MIL-R-83516A(USAF)
AMENDMENT 3
23 FEBRUARY 1984
SUPERSEDING
AMENDMENT 2
28 September 1983

RELAYS, REED, DRY,
GENERAL SPECIFICATION FOR

This amendment forms a part of Military Specification MIL-R-83516A(USAF), dated 3 March 1983, and is approved for use by the Department of the Air Force and is available for use by all Departments and Agencies of the Department of Defense.

FIGURE 1. Typical circuit for operate and release time and contact bounce with typical traces.

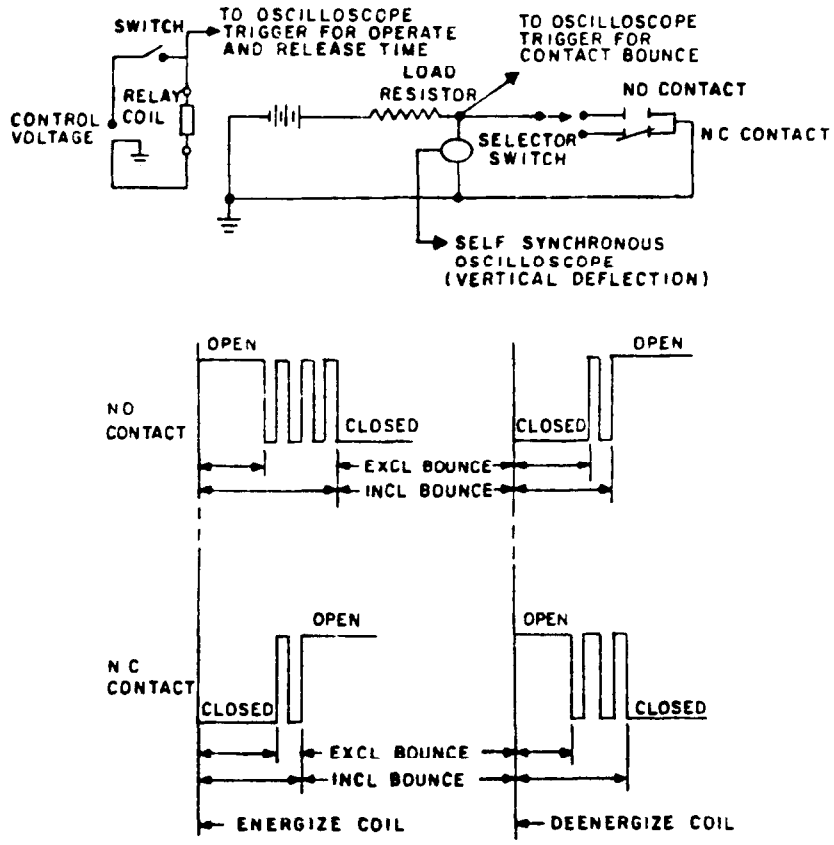
FIGURE 1: Delete and substitute new figure 1 as printed on page 2 of this amendment.
